## **ADDENDUM NO. 2**

**Project:** CITY OF GREAT FALLS INDOOR AQUATICS AND RECREATION CENTER  
**Project No.:** 20-019  
**Date:** OCTOBER 1, 2021  
**Bid Date:** OCTOBER 13, 2021

**6** HANDRAIL CONNECTION DETAIL  
1 1/2" = 1'-0"

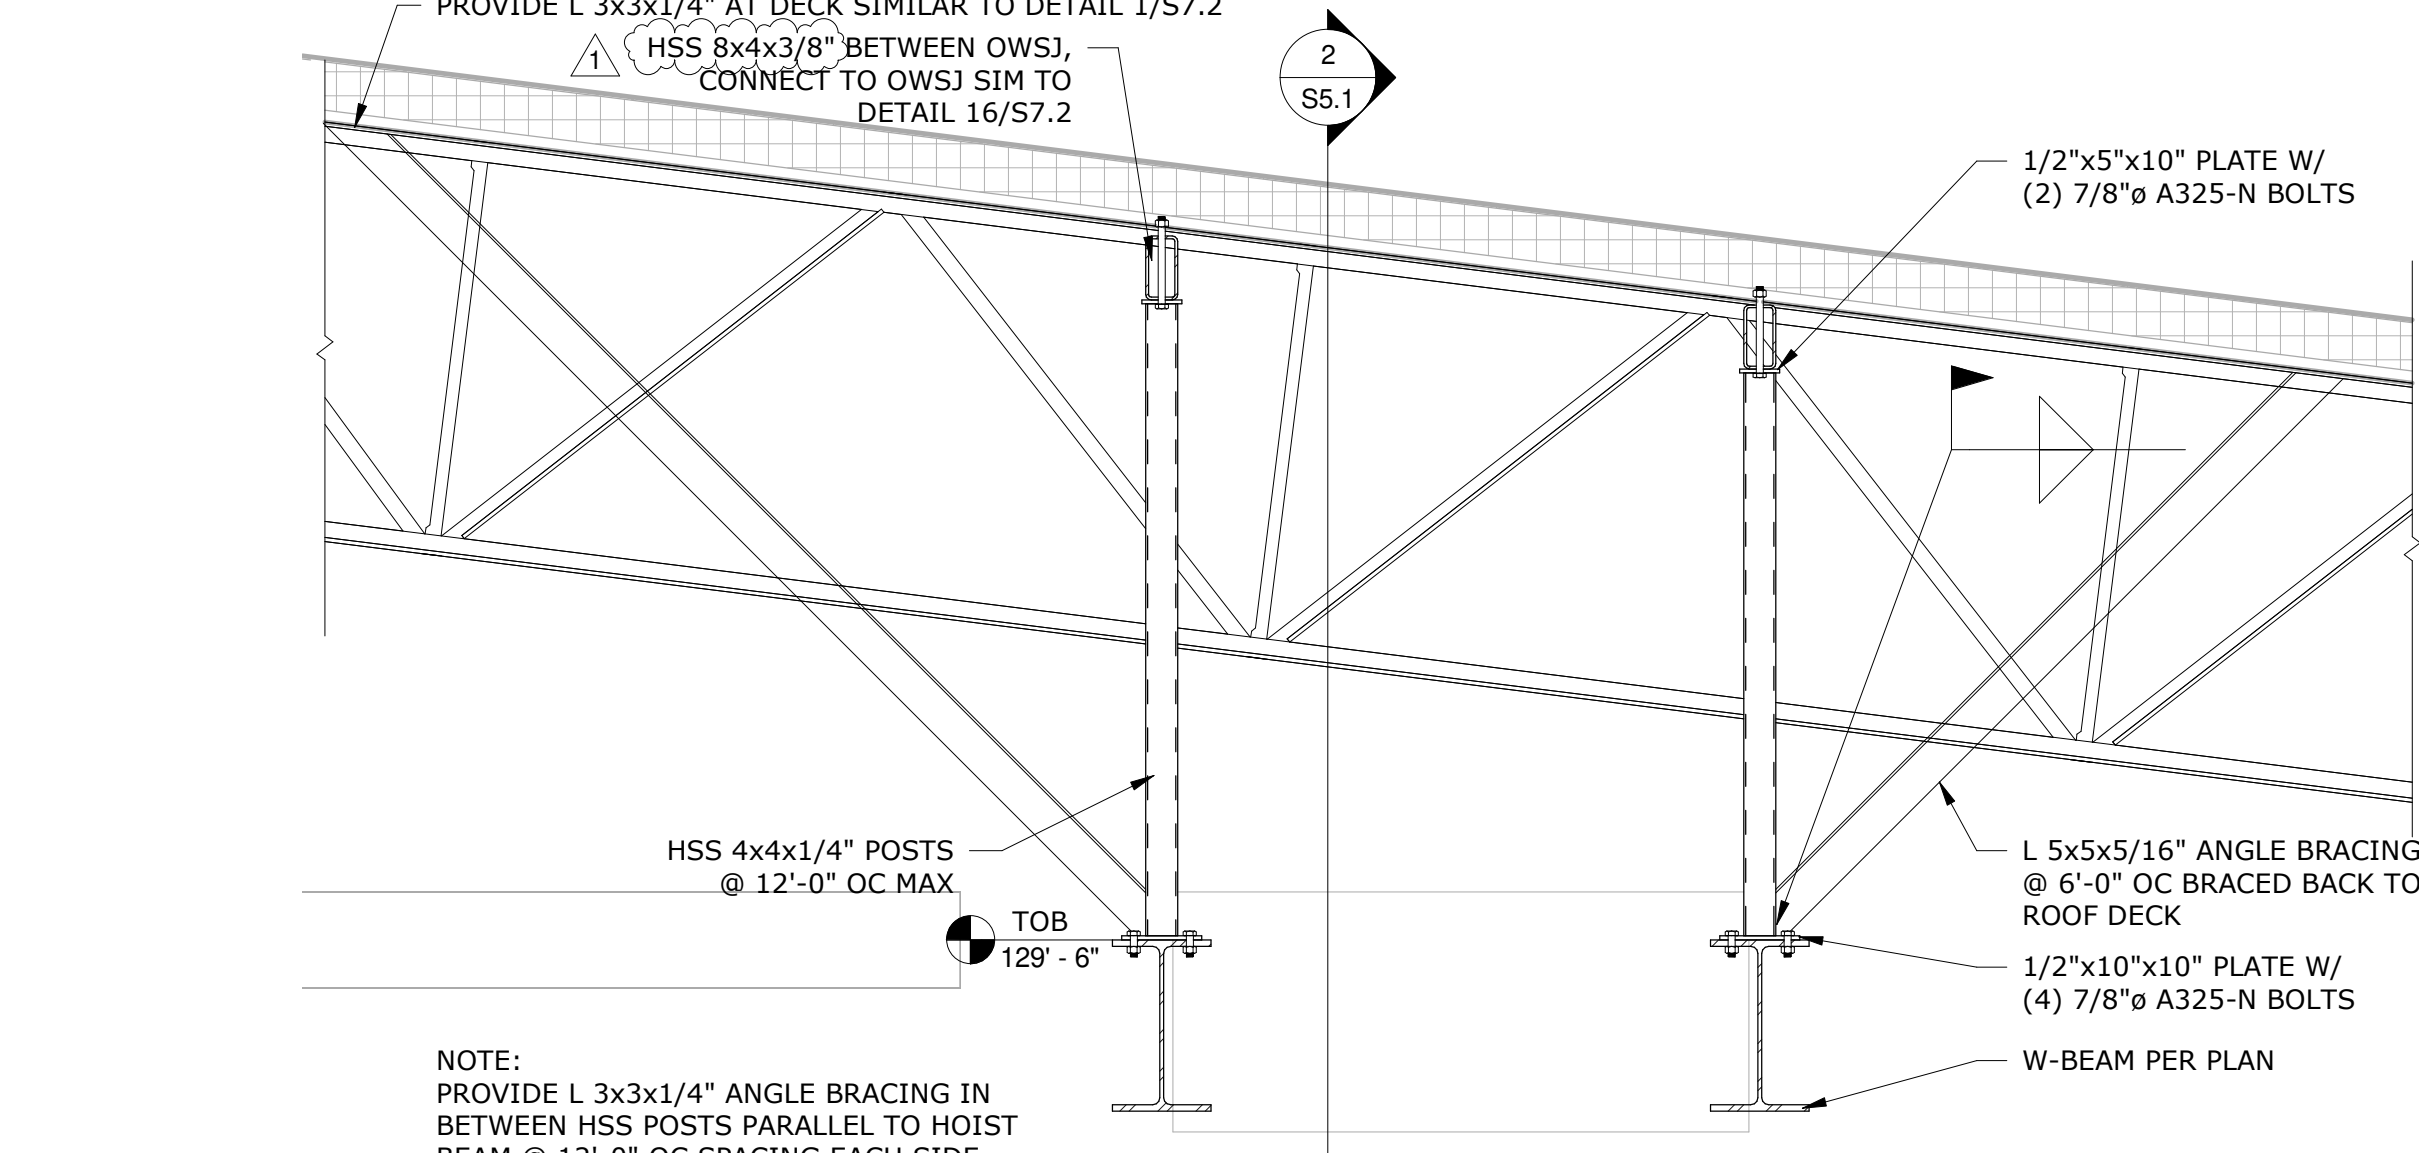
- ITEM NO. 22 **CHANGE:** (4) Structural Sheets updated (See Attachment "E")  
S3.0: Provided slab slope clarification and shifted a footing.  
S4.0: Added 1-special joist callout  
S7.2: Adjusted 3-joist details  
S8.0: Adjusted several joist loading diagrams and added a clarification note.
